CONSTRUCTION SUMMARY

Grovetrail Developments Inc.

LOT NUMBER	PHASE	HOUSE TYPE	CLOSING DATE
37	1	BELVEDERE Elev A	22-Apr-22

38-11 "A"
ELEV.

ELEVATION A
2675
SQUARE FEET

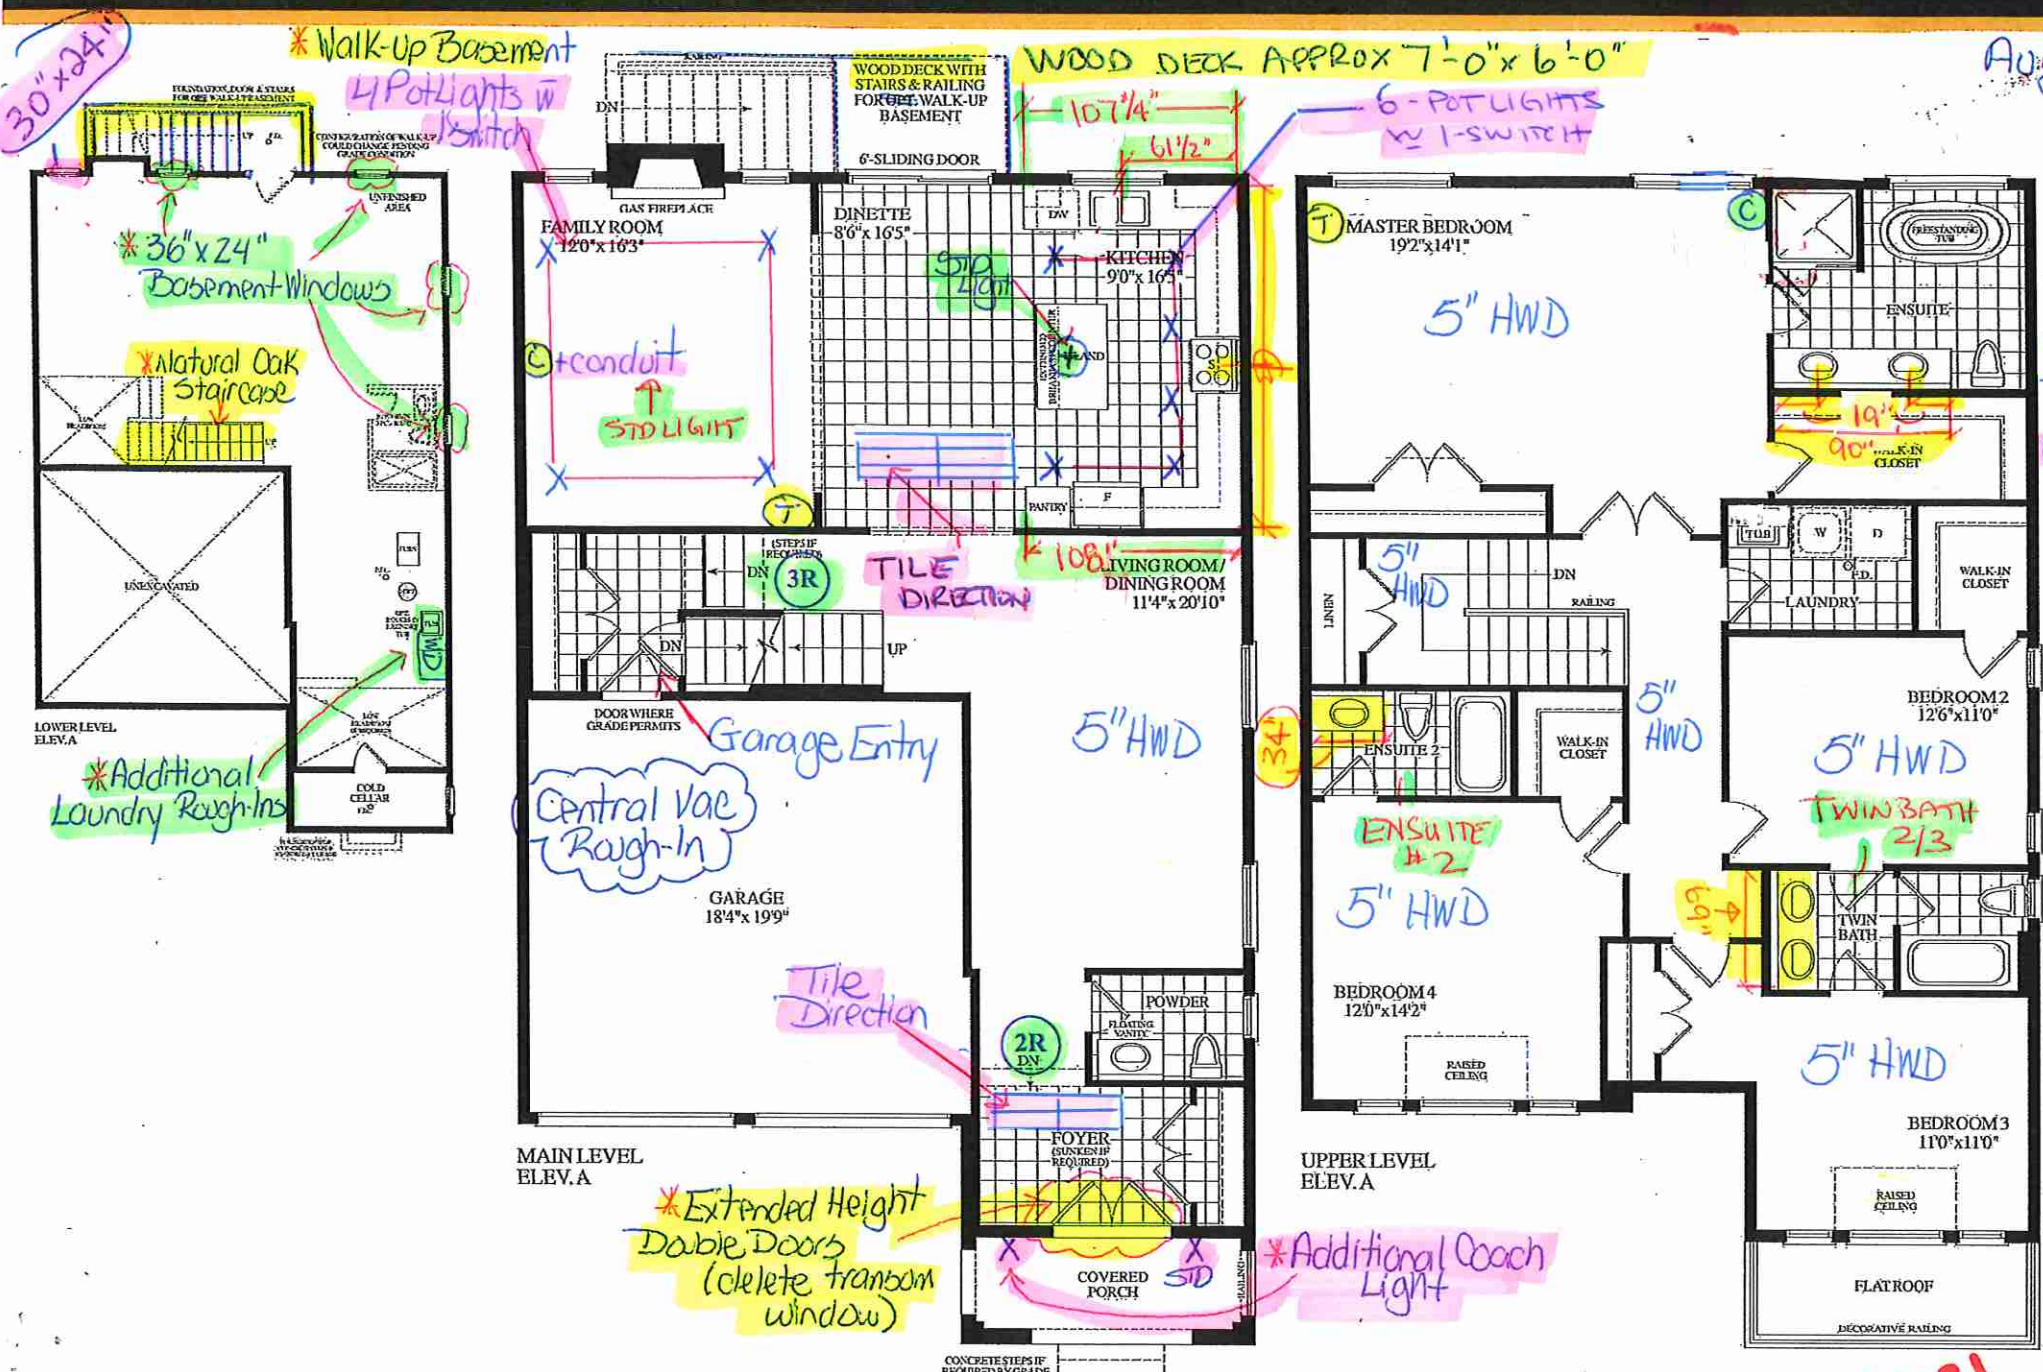
1 - FRONT EXTERIOR - DOORS - Install EXTENDED HEIGHT DOUBLE FRONT DOORS (Delete Transom Window Aboe) in lieu of builder standard height double front doors (See Sketch)
Note:

1 - FRONT EXTERIOR - In addition to builders standard coach light, Install ONE (1) ADDITIONAL EXTERIOR COACH LIGHT - To be installed beside front door (See Sketch)
Note: **Front Door to have TWO (2) Exterior Coach Lights**

DELETE TRANSOM
Extended HEIGHT
DOUBLE POLES

(x2) -
change as provided
Q.E.
CONCH LIGHTS
